**Economic and Social Council**Distr.: General
28 February 2018

Economic Commission for Europe**Inland Transport Committee****World Forum for Harmonization of Vehicle Regulations****Working Party on Passive Safety****Sixty-third session**

Collective amendments to UN Regulations Nos. 16, 44, 94, 129 and 137**Collective amendments to UN Regulations Nos. 16, 94 and 137****Submitted by the expert from the International Organization of Motor Vehicle Manufacturers***

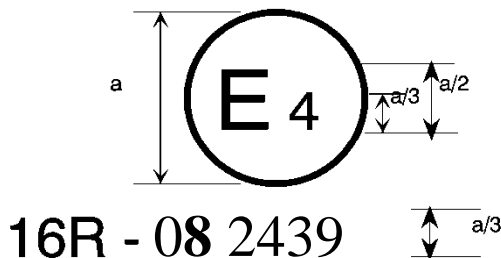
Insert new paragraphs 15.11. to 15.11.6., to read:

"15.11. As from the official date of entry into force of the 08 series of amendments, no Contracting Party applying this UN Regulation shall refuse to grant or

refuse to accept UN type approvals under this UN Regulation as amended by the 08 series of amendments.

- 15.11.1. As from 1 September 2020, Contracting Parties applying this UN Regulation shall not be obliged to accept UN type-approvals to the preceding series of amendments that were first issued on or after 1 September 2020.

- 15.11.2. Until 1 September 2022, Contracting Parties applying this UN Regulation shall accept UN type-approvals to the preceding series of amendments that were first issued before 1 September 2020.

- 15.11.3. As from 1 September 2022, Contracting Parties applying this Regulation shall not be obliged to accept type-approvals issued to the preceding series of amendments to this Regulation.

- 15.11.4. Notwithstanding paragraph 15.11.3., Contracting Parties applying the UN Regulation shall continue to accept UN type-approvals of safety-belts and restraint systems to the preceding series of amendments to the UN Regulation.

- 15.11.5. Notwithstanding paragraph 15.11.3., Contracting Parties applying the UN Regulation shall continue to accept UN type-approvals to the preceding series of amendments to the UN Regulation, for vehicles which are not affected by the changes introduced by the 08 series of amendments.

- 15.11.6. Contracting Parties applying this UN Regulation shall not refuse to grant UN type-approvals according to any preceding series of amendments to this UN Regulation or extensions thereof."

Model B

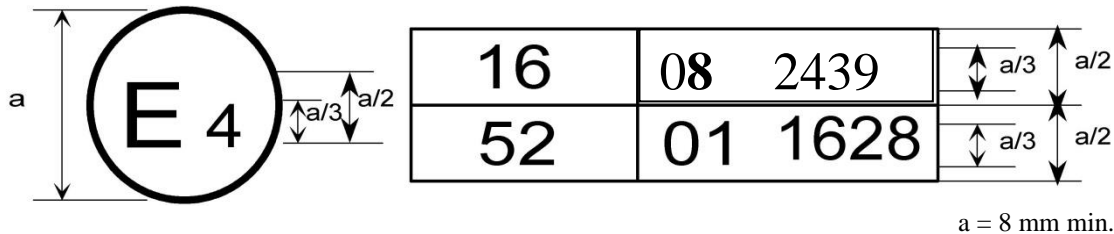
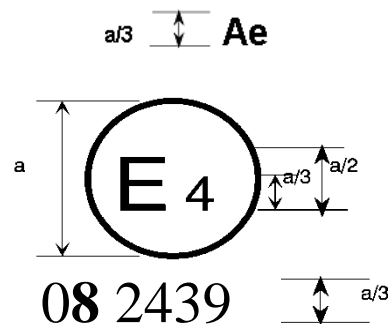
(See paragraph 5.2.5. of this Regulation)

The above approval mark affixed to a vehicle shows that the vehicle type concerned has been approved in the Netherlands (E4) pursuant to UN Regulations Nos. 16 and 52¹. The approval numbers indicate that, at the dates when the respective approvals were given, UN Regulation No. 16 included the 08 series of amendments and UN Regulation No. 52 the 01 series of amendments.

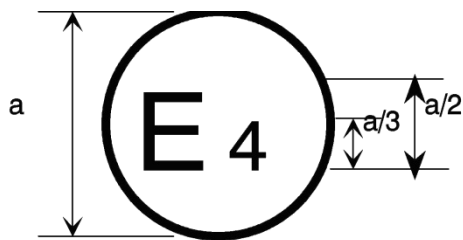
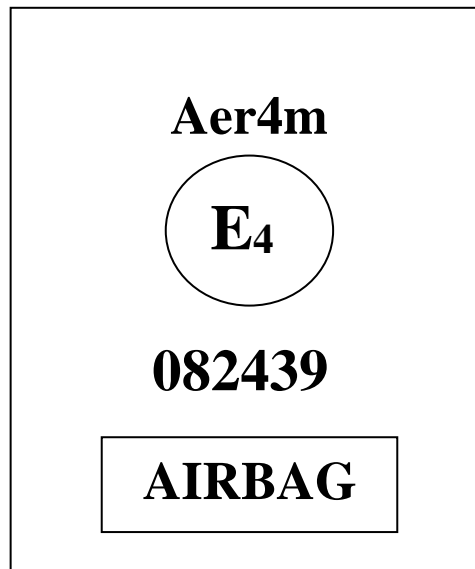
The belt bearing this type-approval mark is a three-point belt ("A") with a multiple-sensitivity ("m") type 4N ("r4N") retractor, in respect of which type-approval was granted in the Netherlands ("E4") under number 082439, the Regulation already incorporating the 08 series of amendments at the time of approval. This belt shall not be fitted to vehicles of category M₁.

The safety-belt bearing this type-approval mark is a three-point belt ("A") fitted with an energy absorber ("e"), approved as meeting the specific requirements of paragraph 6.4.1.3.3. of this Regulation, and with a multiple-sensitivity ("m") type 4 ("r4") retractor, in respect of which type approval was granted in the Netherlands ("E4") under the approval number 082439. The first two digits indicate that the Regulation already incorporated the 08 series of amendments at the time of the approval. This safety-belt has to be fitted to a vehicle equipped with an airbag in the given seating position."
